Federal Register

14 CFR Part 39

[Docket No. FAA-2022-1647; Project Identifier AD-2022-01379-T; Amendment 39-22438; AD 2023-10-02]

Airworthiness Directives; Transport and Commuter Category Airplanes

Figure 1 to paragraph (g)(1)(i)—*Fundamental Effective Isotropic PSD at Outside Interface of Airplane Antenna*

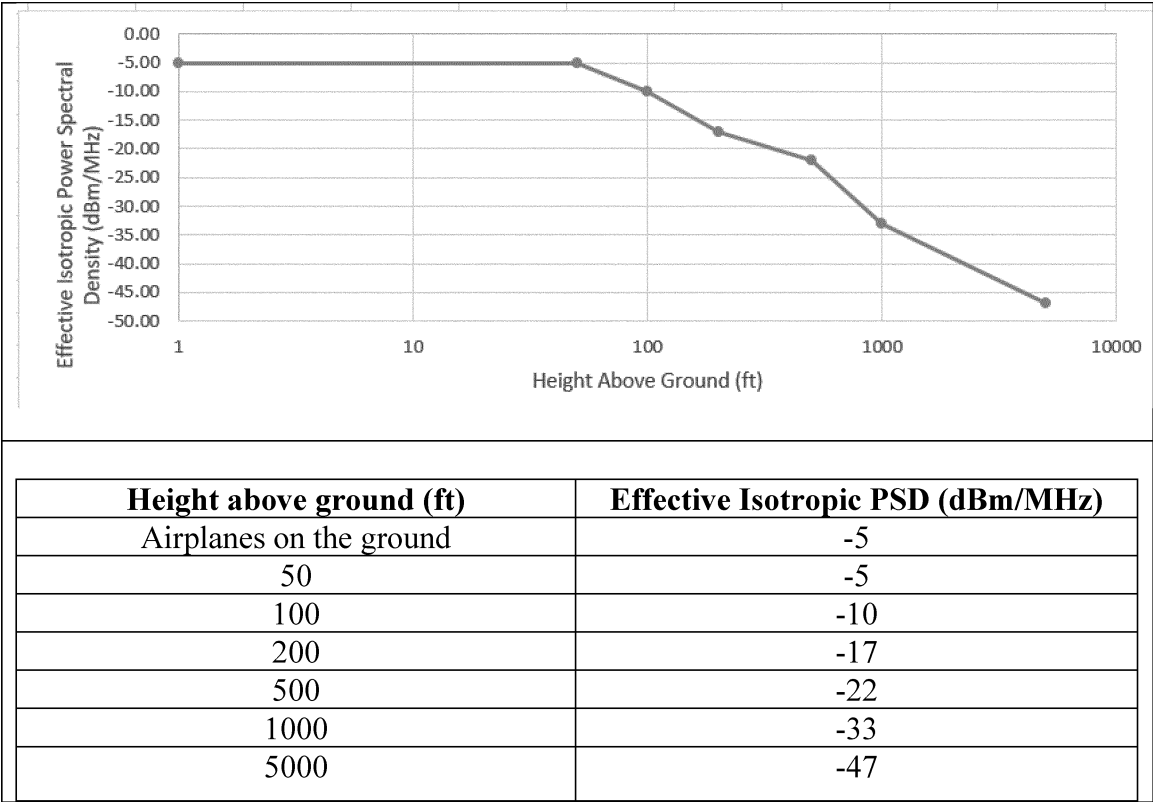
Comment summary: Textron Aviation requested the FAA clarify at what reference point the PSD requirements apply. The commenter stated it assumed that they apply at the radio altimeter receive antenna input, such that antenna characteristics, coax loss, and filter characteristics would be included in the determination.

FAA response: The FAA agrees and has changed the title of figure 1 to paragraph (g)(1)(i) of this AD to reflect that the PSD requirements apply at the

antenna input to the radio altimeter, and that the figure applies to the outward facing side of the antenna.

Figure 2 to paragraph (g)(1)(ii)—*Spurious Effective Isotropic PSD at Outside Interface of Airplane Antenna*

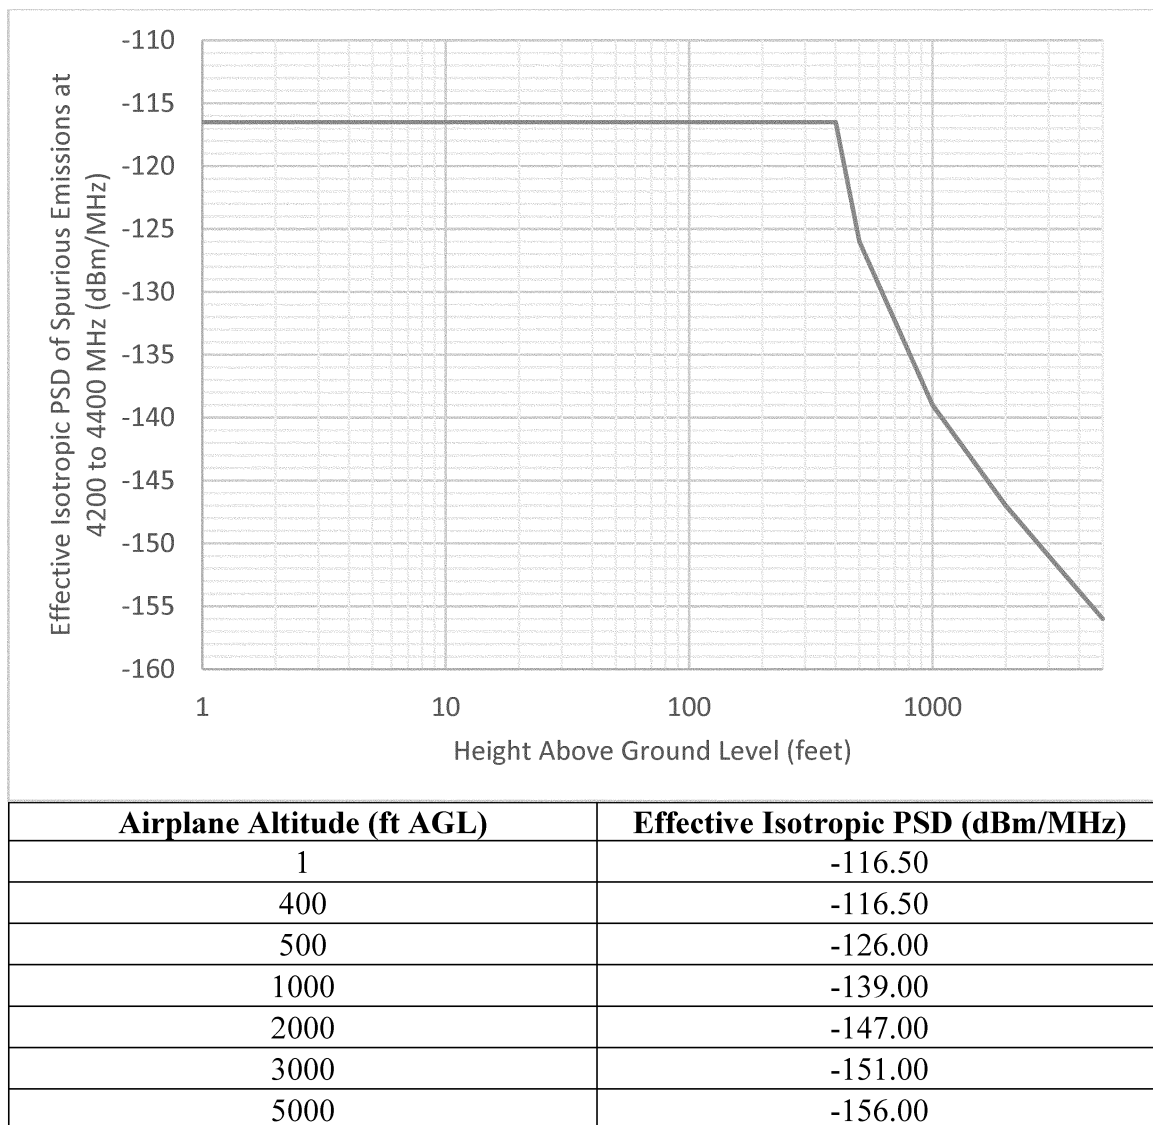
Comment summary: AIA requested that the FAA provide more information about the tolerances for determination of whether an airplane is radio altimeter tolerant. Several commenters requested that the FAA add a new figure indicating the spurious tolerance, similar to the figure with the PSD tolerance curve, and a specification of the altitude dependence for spurious tolerance.

FAA response: The FAA agrees and has replaced the proposed fixed emission level with a spurious PSD tolerance curve in figure 2 to paragraph (g)(1)(ii) of this AD. Subsequent figures have been redesignated accordingly.
